A message from Technical Standards

CitiPower/Powercor Technical Standards Update for May 2020

Release date: 10 June 2020

EM531 FOLCB Assembly & EM535 Junction Box Assembly

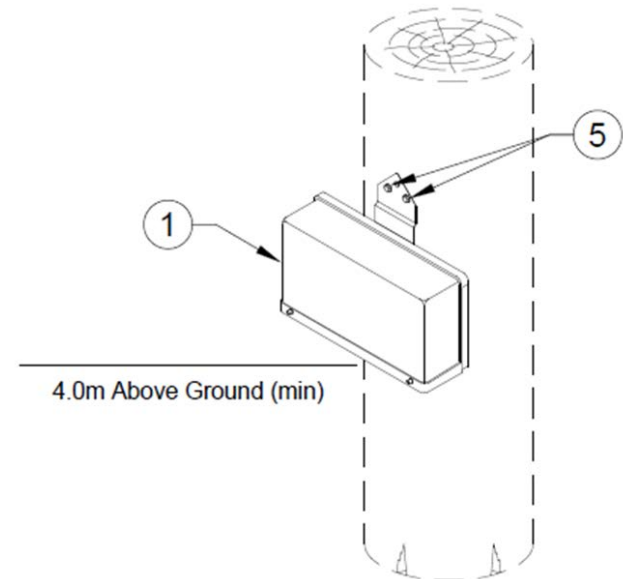
- Technical Standard EM531 has been updated to remove the use of M10 x 50mm coach screws and replace them with the use of 14 gauge 40mm self tapping wood screws to attach an FOLCB to a wood pole.
- Technical Standard EM535 has been updated to remove the use of a single M10 x 50mm coach screw and replaced it with the use of two 14 gauge 40mm self tapping wood screws to attach a junction box to a wood pole.

- The change has been made based on field feedback advising that the self tapping screws are easier to install when compared to coach screws (which require a pilot hole to be drilled prior to coach screw).
- Two screws are also being used with the junction box to prevent it from swinging.

ER101 & ER121 - ACR Assembly - Three Phase, 22kV, 630A, Rural & Urban

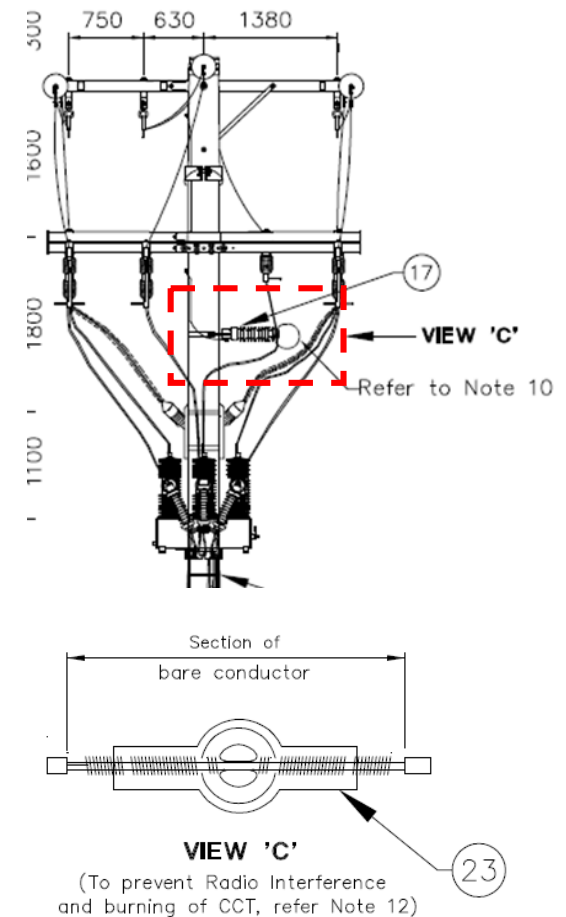
- Technical Standards ER101 and 121 have been updated to provide further guidance on the attachment arrangement of the CCT aluminium dropper to the bridging insulator.
- Additional materials required for this attachment arrangement have also been added to the standard component assembly.
- For the wood pole version of the arrangement an insulator saddle (EE944) has also been added for use with the centre phase bridging insulator.

- Field feedback advise that further information was required for the attachment arrangement of the CCT aluminium dropper to the bridging insulator.

Figure 3 - Typical luminaire details required on a construction plan

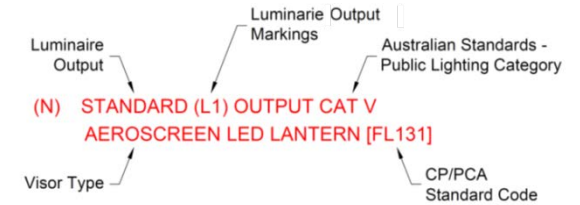
- Technical Standard FL011 has been updated to align the Technical Standards with information that is painted on the base of luminaires.
- The standards has also been updated to specify the luminaire information required on construction plans. See figure 3.
- Luminaire packaging will now also have this information printed, to allow easy identification.

- The standard has been updated to align the marking codes painted on the luminaire with the standards, construction plans and packaging.
